**WESTON RESERVOIR DAM
MA 00798**

Dam Safety Draft Report

NATIONAL PROGRAM OF INSPECTION OF NON-FEDERAL DAMS
DRAFT REPORT REVIEW COMMENTS

Weston Reservoir DAM, IDENTITY NO. MA 00798

PLAN VIEW OF DAM

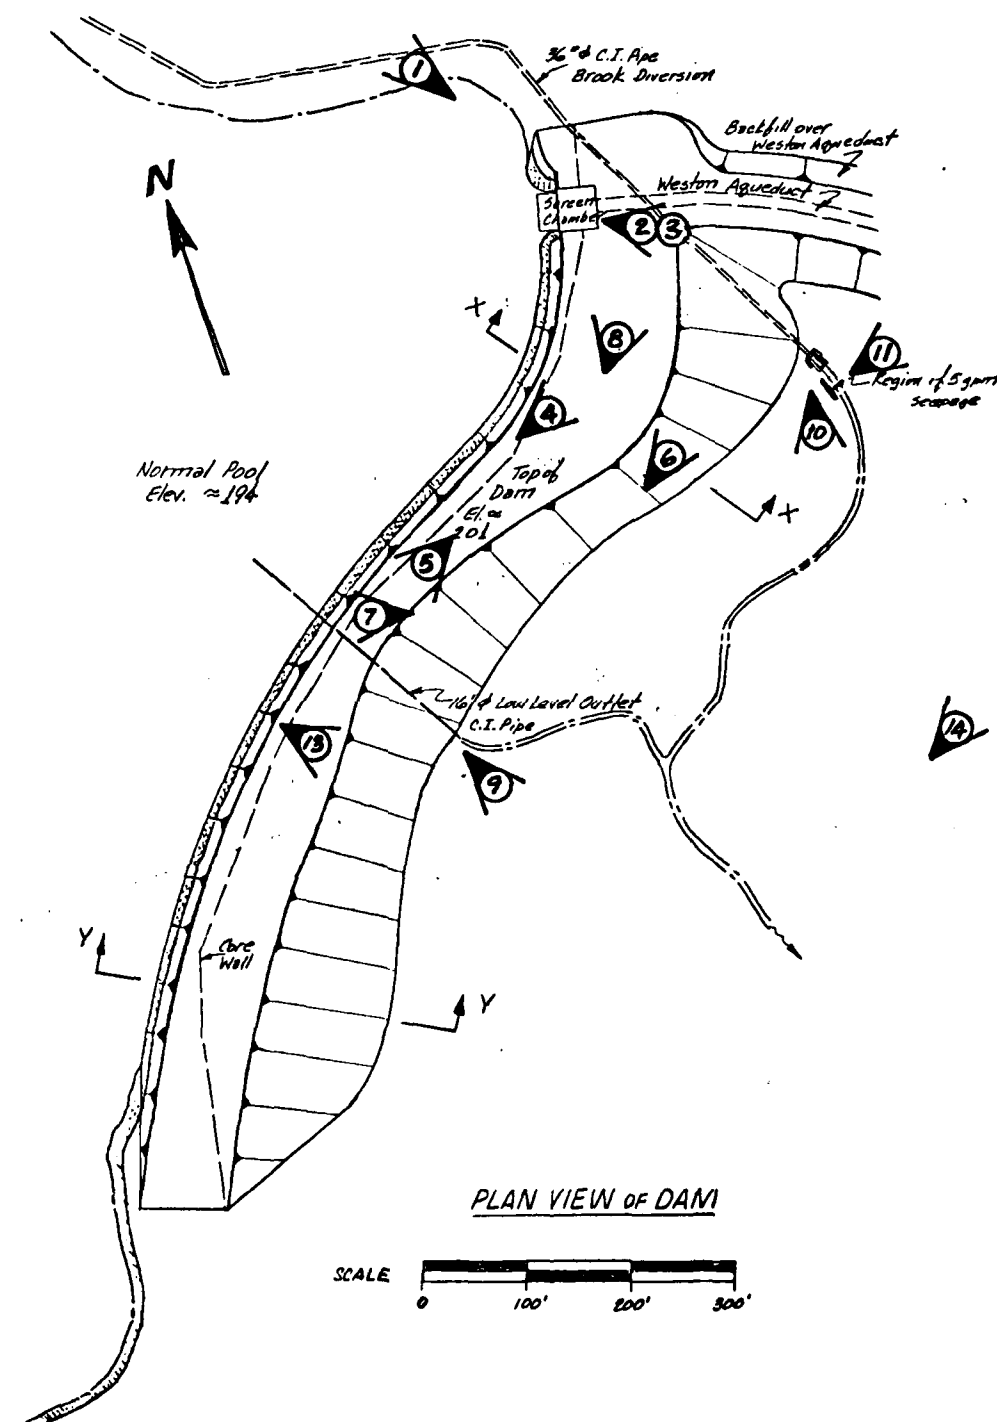
- 11MIF*
Yellow
- Brief Assessment* 1) Max dam height should be 32 feet.
(Section 1)
- Brief Assess. § 7-1 pm. 7.2* 2) add "qualified" before registered prof. engineer
- Appendix C* 3) Show area of seepage on photo plan.
